NOTICE OF
CHANGE

MIL-STD-883E
NOTICE 3
5 November 1999

DEPARTMENT OF DEFENSE
TEST METHOD STANDARD
MICROCIRCUITS

1. THE FOLLOWING TEST METHODS OF MIL-STD-883E HAVE BEEN REVISED AND SUPERSEDE THE TEST METHODS LISTED:

* FIGURE 2032-8Bh. Classes H and K via plug fill criteria.

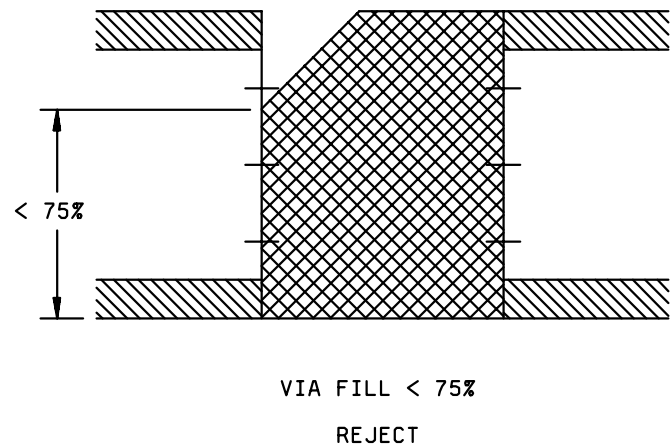
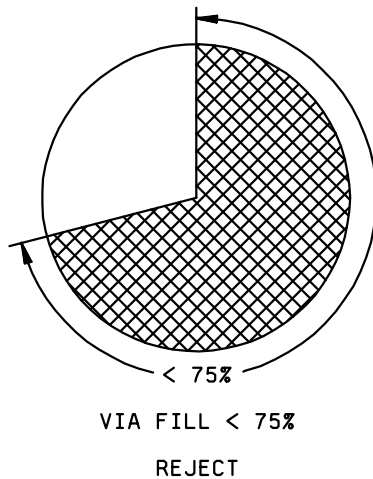
- * 3.1.1.10 Substrate plug via defects, "low magnification". When inspected from each side of the substrate, no element shall be acceptable that exhibits:
- A complete void through the via.
 - Any lifting, peeling, or blistering of the via metallization.
 - Via fill less than 75% of the total surface area of the via plug and less than 75% of the substrate thickness.
- * NOTE: These are minimum requirements. Via flatness and other requirements shall be in accordance with the applicable detail drawings. The via fill may consist of thick film metallization.

* FIGURE 2032-29h. Class H laser nicking criteria exception for the last rung of a resistor ladder.

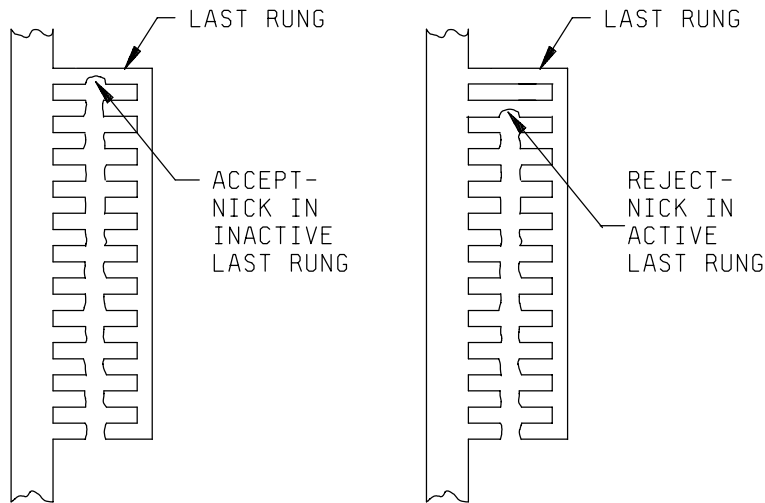
- 3.1.7 d. (Continued.)
NOTE: This criterion does not apply to the last rung of a resistor ladder if the last rung is inactive (see figure 2032-29h).

* FIGURE 2032-43Bh. Classes H and K plug via fill criteria.

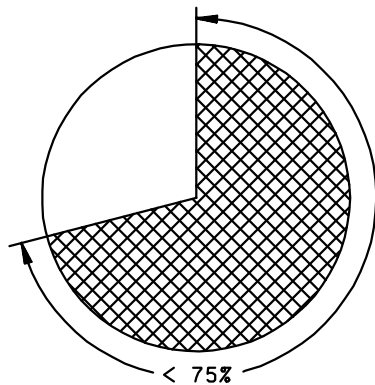
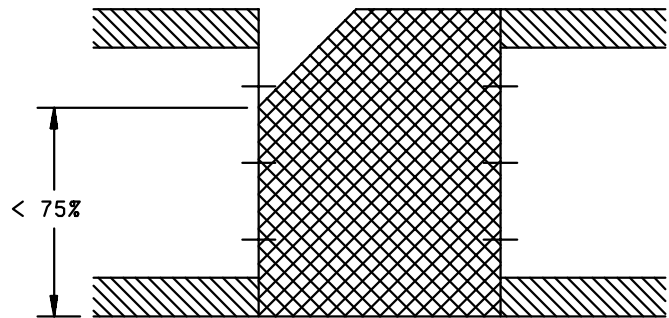
- * 3.2.1.9 Substrate plug via defects, "low magnification". When inspected from each side of the substrate, no element shall be acceptable that exhibits:
- A complete void through the via.
 - Any lifting, peeling, or blistering of the via metallization.
 - Via fill less than 75% of the total surface area of the via plug and less than 75% of the substrate thickness.
